SUBJECT: Forwards mod. to deviation request in FSAR Amend 13, Section 9B.2.1, 9B.2.2 & Figures 9B-8, 9, 10 & 11. Updated response to FSAR Question 9A-98 part (2) also encl. Changes will be incorporated in next FSAR amend.

Subject: Palo Verde Nuclear Generating Station (PVNGS)
Units 1, 2, and 3
Changes to the PVNGS FSAR.
Docket Nos. STN 50-528/529/530
File: 84-056-026; G.1.01.10

Attached are two changes to the PVNGS FSAR. Attachment 1 is a modification to a deviation request in FSAR Amendment 13, Section 9B.2.1, 9B.2.2 and Figures 9B-8, 9, 10, and 11.

Palo Verde Nuclear Generating Station FSAR
	CONTROL BUILDING PLAN AT ELEVATION 140'-0"
	Figure 75-11

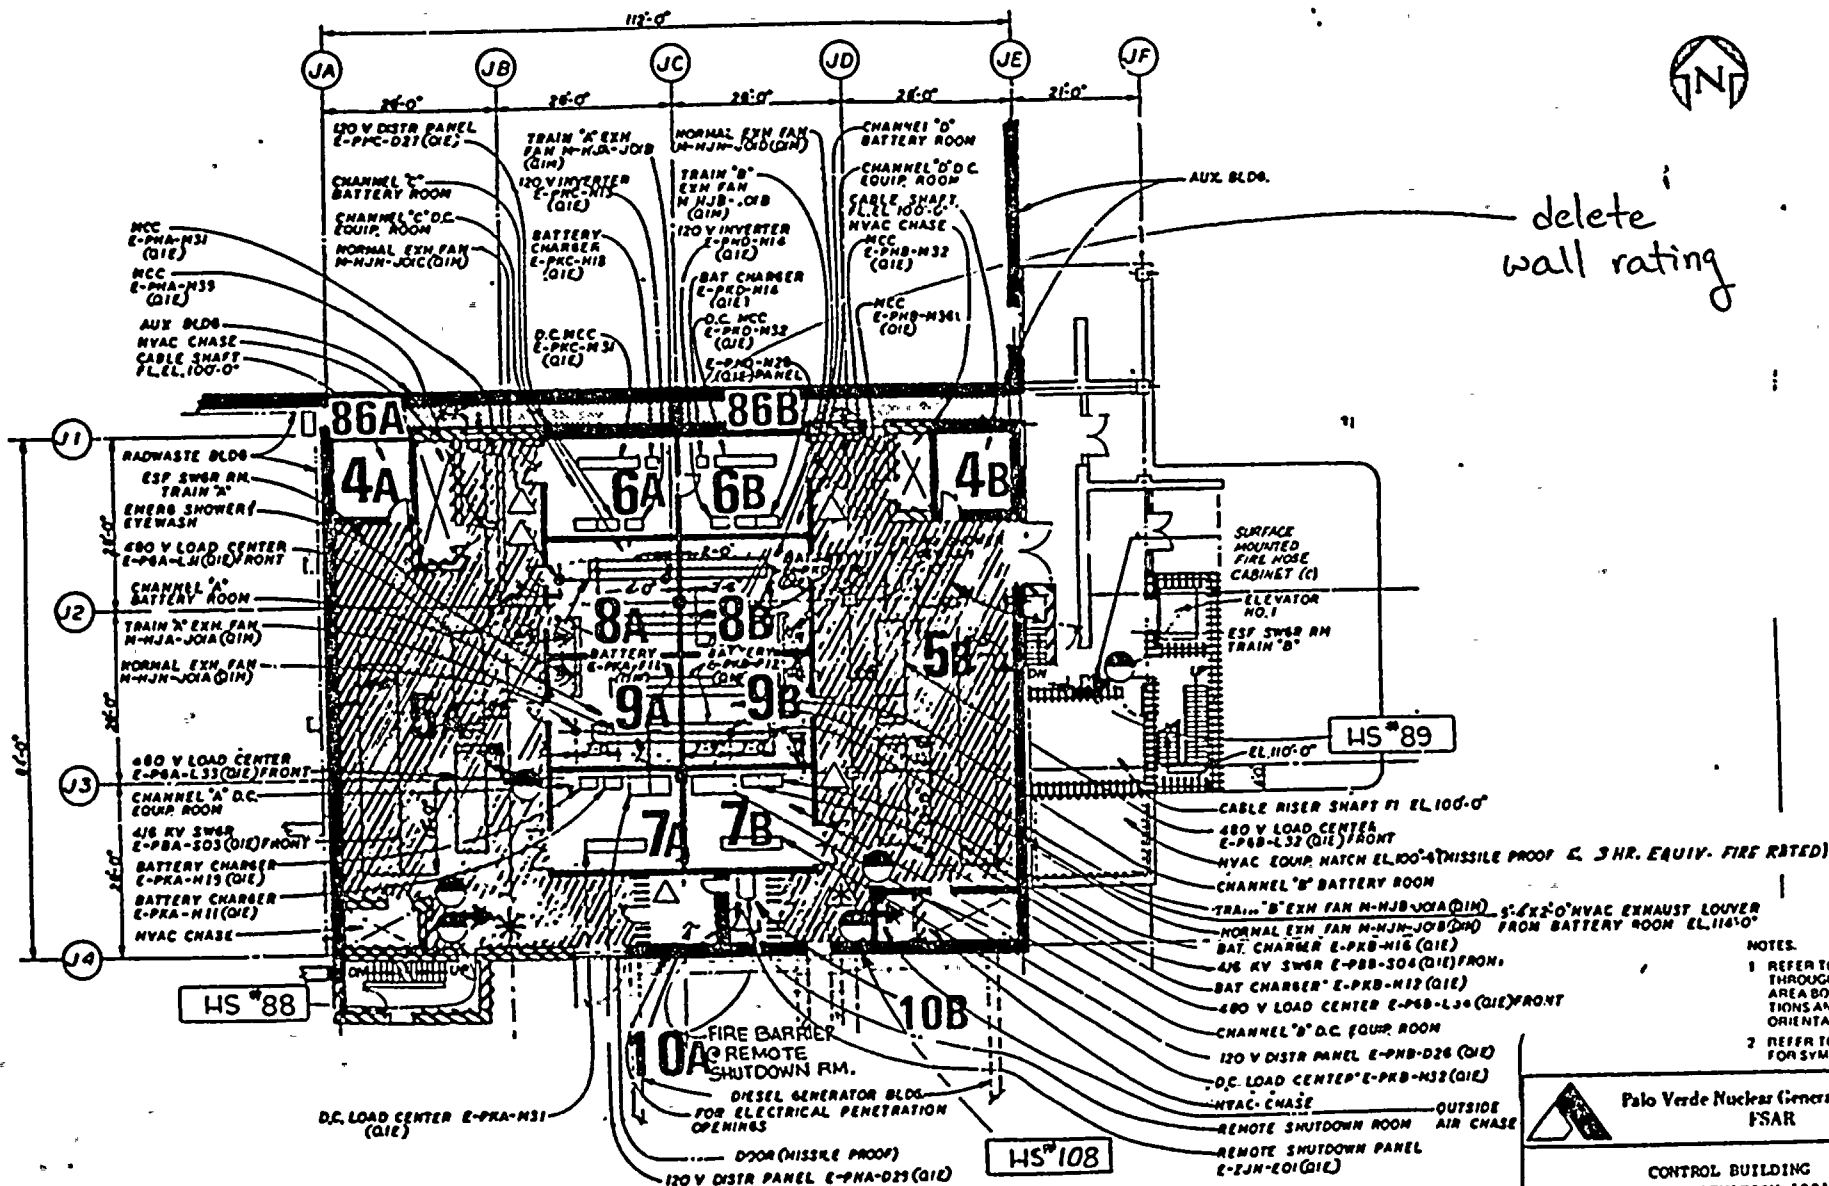
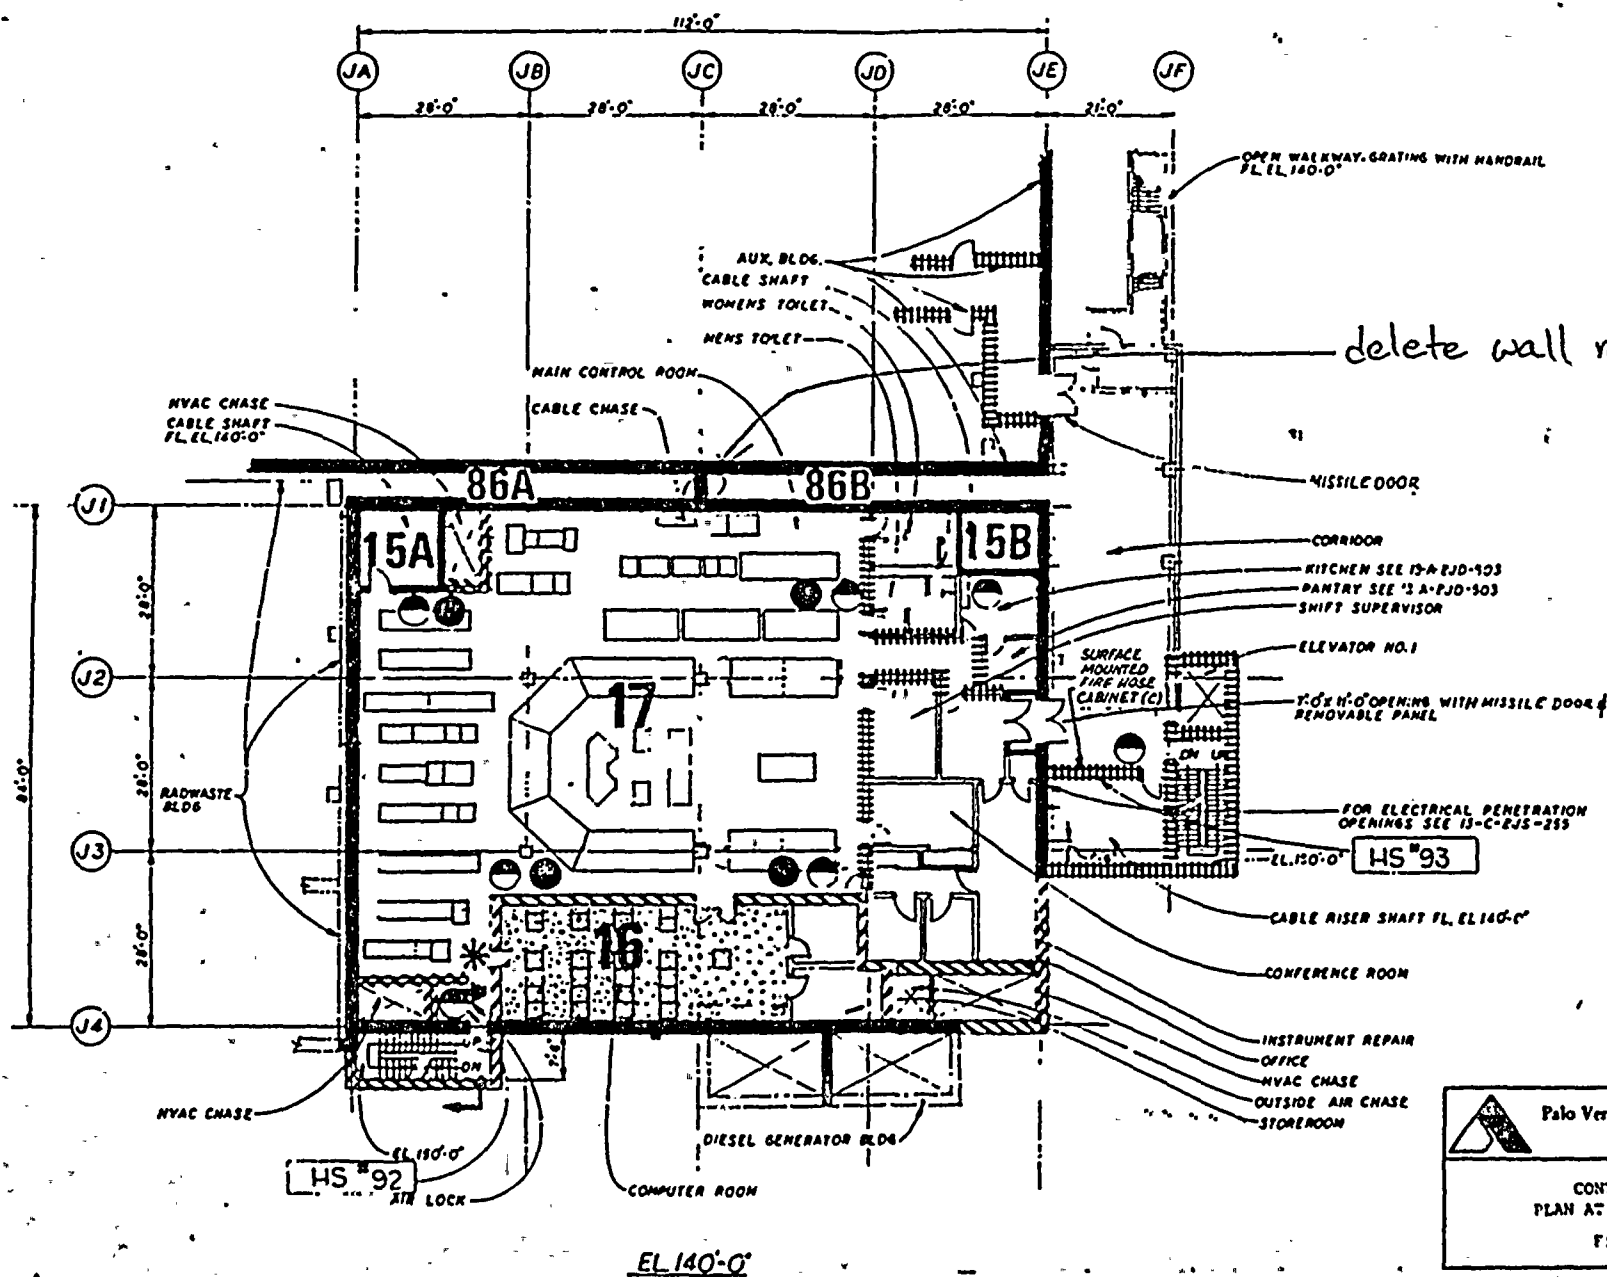
East: ^{g Non-} 3-hour rated area boundary wall common of heavy concrete construction to Fire Area II, Zone 86B, at column line JC.

West: Non-rated area boundary wall common to Fire Area X at column line JA.

West: -3-hour ^{Non-}rated area boundary wall common
to Fire Area I, Zone 86A, at column
line JC.

5. A deviation is requested to Section III.G.2 to the extent that it requires three-hour rated barriers to separate circuits of redundant trains.

The central wall of the dead space compartment between the Auxiliary and Control Buildings is a fire area boundary common to Fire Area I (Zone 86A) and Fire Area II (Zone 86B) at elevations 74'0", 100'0", 120'0", and 140'0". The wall is reinforced concrete with a nominal 6-inch seismic gap. The seismic gap is covered by solid 1/4-inch steel plates bolted to each side of the concrete wall. The fit is snug and there is no path for heat or smoke to travel through the plate steel. The dead air space between the steel plates will have an insulating quality thus minimizing radiant heat transfer to the other side as well as eliminating convected heat through the barrier. Zonal detection and automatic deluge water spray covers the predominant in-situ combustible (cable trays at elevations 100'0" and 120'0"). The train A safe shutdown cable trays of Zone 86A and the Train B safe shutdown cable trays of Zone 86B are located approximately 10 feet from the central wall with no intervening combustibles. The equivalent fire severity for each of Zones 86A and 86B is approximately 107 minutes. Fire brigade response (within 30 minutes) is expected before significant degradation of the existing fire barriers would occur.

The existing design provides equivalent protection to that required by Section III.G.2, and upgrading the existing design to a 3-hour rating would not significantly enhance the protection currently provided.
